REMARKS

These remarks are in response to the Office Action dated December 10, 2007. Claims 1, 4-6, 8-19, 21-26, and 29 are pending in this application. Claims 31-33 are added. No new matter is presented in the claim amendments and new claims presented herewith.

Application Serial No. 10/537,382
Client/Matter No. 12867-3
Reply to Office Action dated December 10, 2007

7 / 14

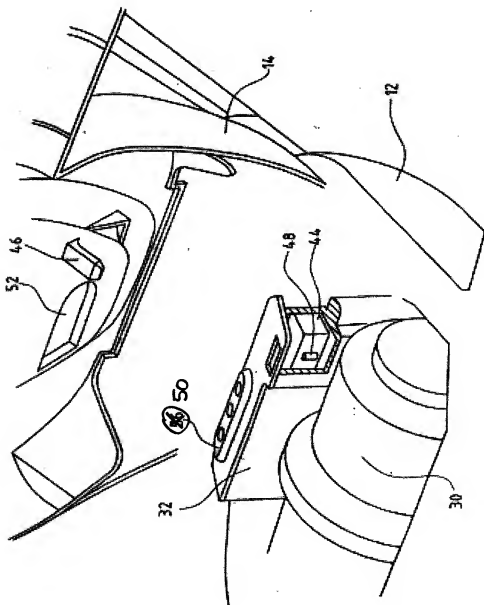
The drawings are objected to because the reference number "56" has been used to designate both an airflow passage and indicator lights. A Replacement Sheet is attached for amended Fig. 6, where reference number "56" has been replaced with reference number "50." Support exists for this amendment based upon Fig. 4 and the specification.

8 / 14

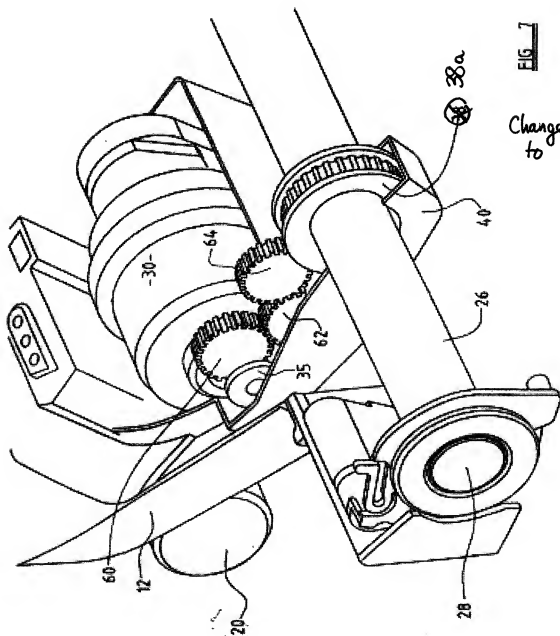
The drawings are also objected because the reference number "38" has been used to designate both a drive wheel and a brush bar pinion. The Examiner's suggestion has been implemented. A Replacement Sheet is attached for amended Fig. 7, where reference number "38" has been replaced with reference number "38a."

Change "38"
to "38a"
